Capital Project No. WP-169
Long Term Control Plan II

Combined Sewer Overflow Long Term Control Plan for Westchester Creek

Appendix E: Supplemental Documentation

**The City of New York
Department of Environmental Protection
Bureau of Wastewater Treatment**

Figure 2-8. HP CSO Bacteria 2014 Sampling Data (Revised)

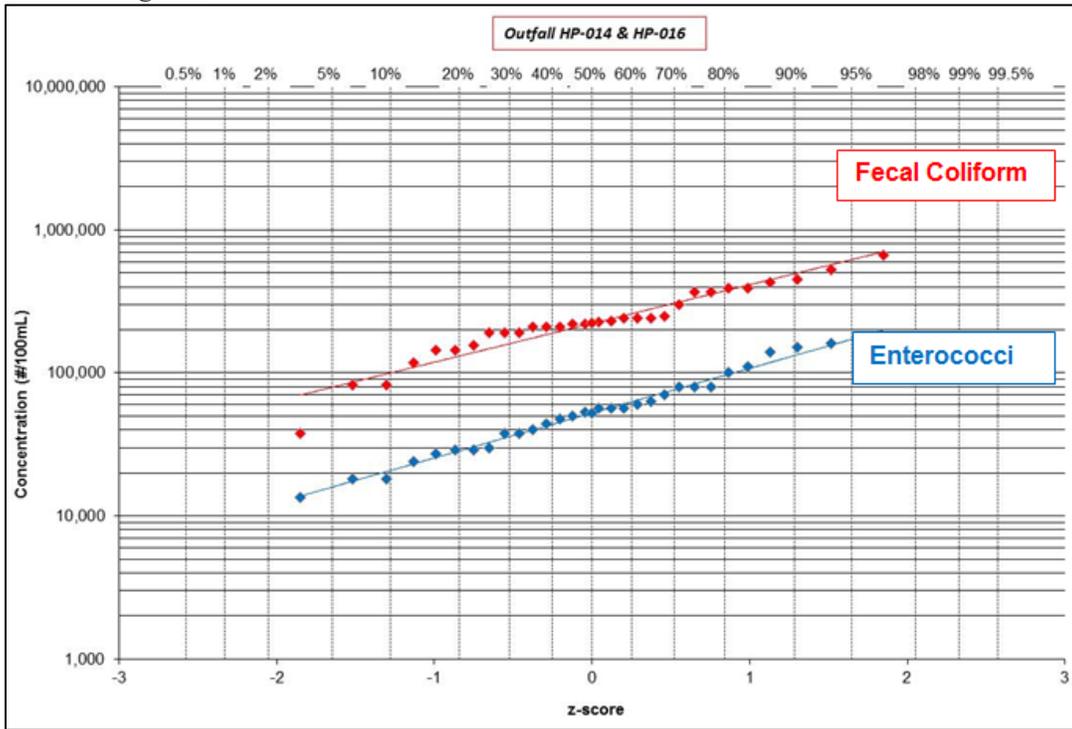
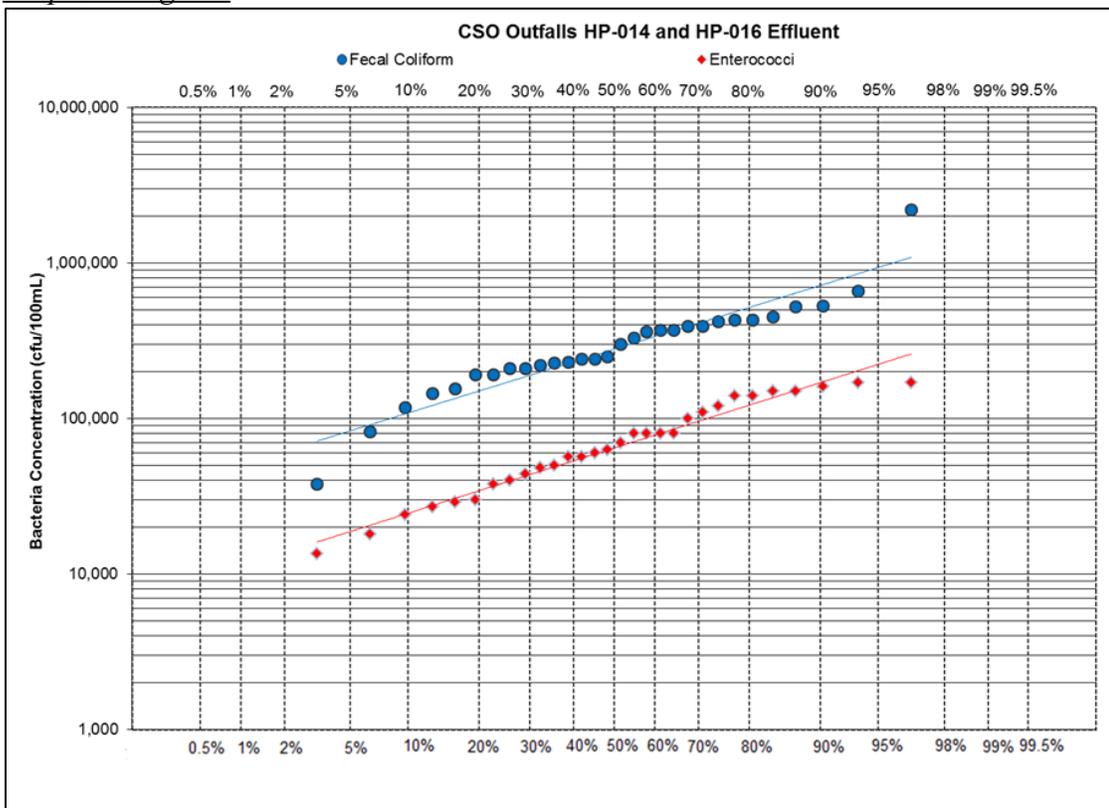
Figure 2-8 presents the fecal coliform and enterococci concentrations from the sampling of CSO Outfalls HP-014 and HP-016, however, according to the data provided to the Department in the file “Westchester Raw data for DEC May, 14, 2014”, one data point for HP-016 had a count of bacteria of over 2 million cfu/100mL. This data point does not appear to be included in Figure 2-8 and should be included to accurately to assess concentrations of CSO.

The data noted by DEC were not excluded from the analysis. The labels “Fecal Coliform” and “Enterococci” used in Figure 2-8 were mistakenly placed over a few data points with low return frequencies including the 2 million value noted by the DEC. The figure has been replaced.

Figure 4-3. Proposed WWFP Element CSO-29A Modification, Pugsley Parallel Sewer (Revised)

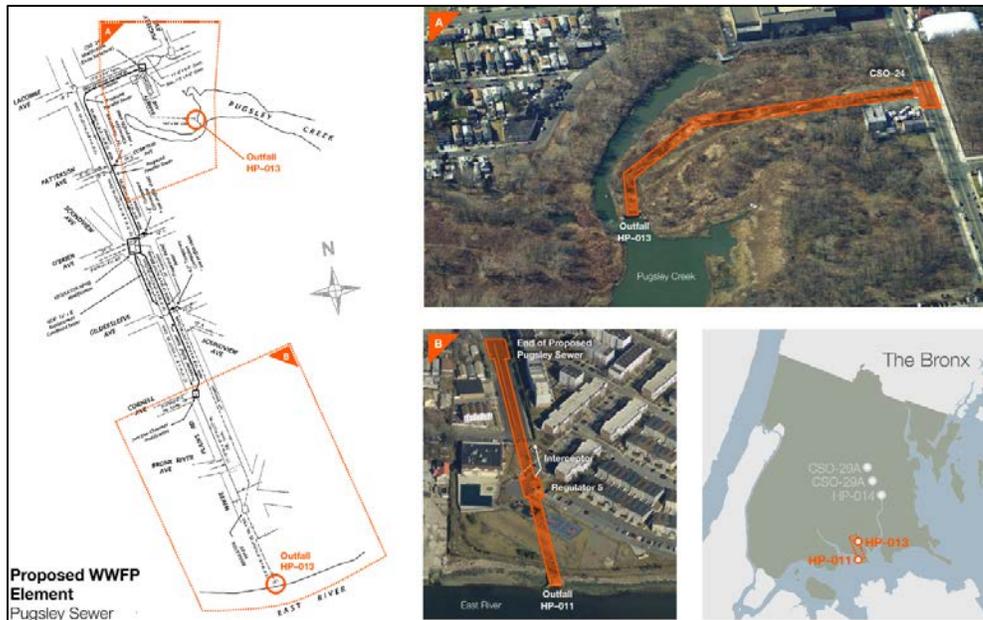
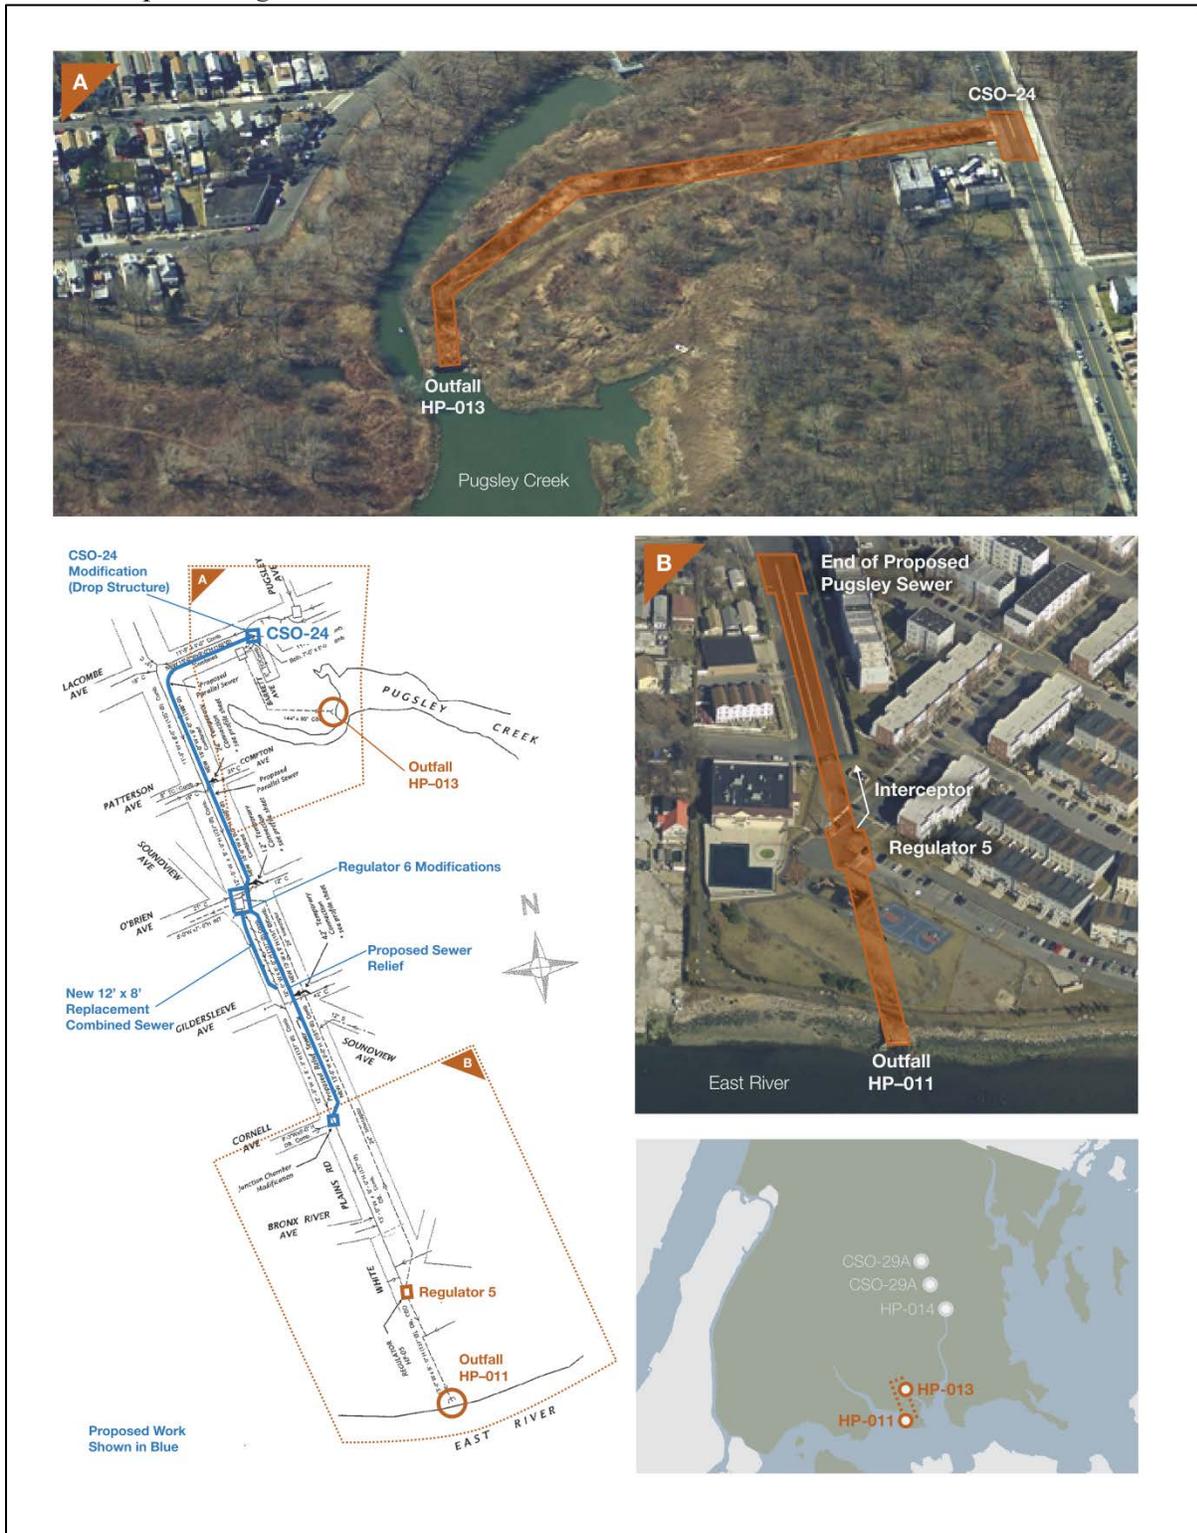
Figure 4-3 should include a more legible illustration of the parallel sewer for Pugsley Creek.

The figure has been revised.

Figure 8-2. Proposed Route of Throgs Neck PS FM Extension to Hunts Point WWTP

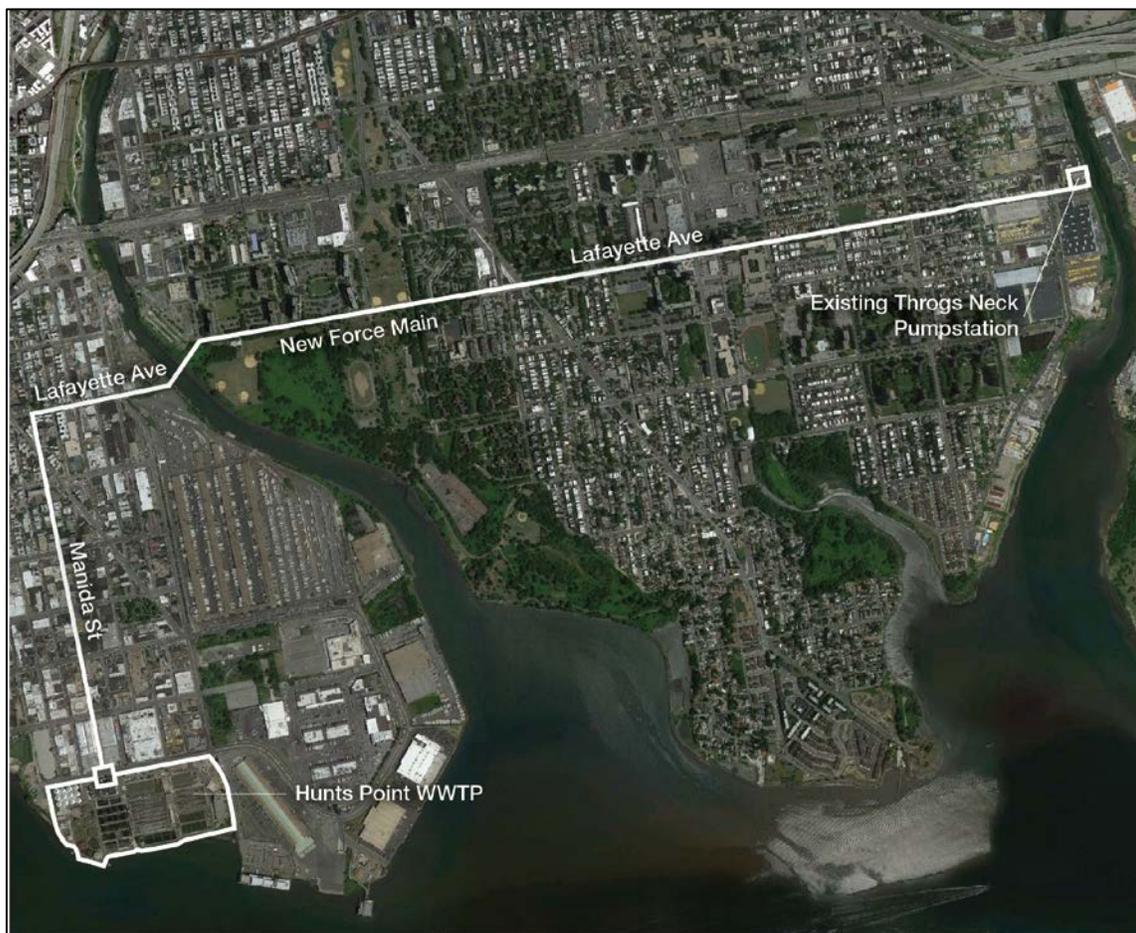
Figure 8-2 indicates that the size of the dewatering pump station for in-line storage is 509 MGD; however Table 8-2 indicates that the pump station would be 3 MGD. Reconcile the discrepancy.

The size of the pump station is 3.0 MGD; Figure 8-2 and Table 8-2 have been reconciled.
